Subdivision and Land Development Cover
Page for SLD # 01-22

Project Name: 931 Spring Mill Avenue, LLC

Address: 927-31 Spring Mill Avenue

Re: MCPC #22-0009-001
Plan Name: WESTY Project
20 dwelling units/17,950 gross sq. ft. /0.40 acres
Situate: Spring Mill Avenue (south)/ Lime Street (west)
Whitemarsh Township / Borough of Conshohocken

a. Functionality of the sub-surface parking arrangement.

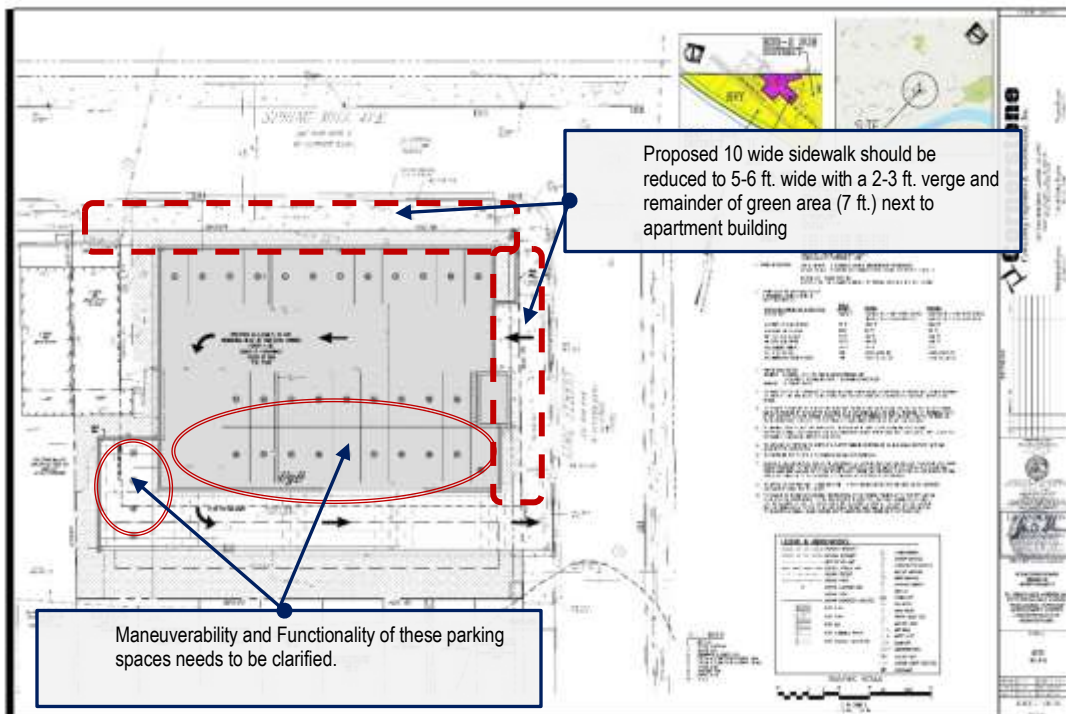
The plan proposes a number of parking spaces in which the functionality and maneuverability of vehicular parking is questionable. The plan shows a number of parking spaces (shown as #26- #35) under the building and immediately adjacent to building’s exterior wall that appear to be double-stacked with the opposite parking spaces (#17-25), which would prevent access. It is not clear from the applicant’s submitted plans whether cars are designed to enter directly to these spaces (#26- #35) from the paved area along the property’s southern boundary. The applicant should clarify how these spaces are designed to function effectively and safely, and we recommend the applicant provide the township with an architectural elevation of the south façade. Also, several parking spaces, (#1-#4) shown outside the sub-surface structure and adjacent to a retaining wall appear to have a blind spot and limited viewing for drivers backing out into the drive aisle. The applicant should provide architectural and structural details on how these spaces will function. These issues are highlighted below in the annotated graphic.

The applicant’s parking lot arrangement does not adequately address the township’s Off-Street Parking requirements as it does not include “ADA” parking spaces required by Section 116-184.A. According to the Zoning Code, the applicant should provide the applicable number of “ADA” spaces based upon the requirements set forth in the latest edition of the International Building Code and its associated ANSI Standards.
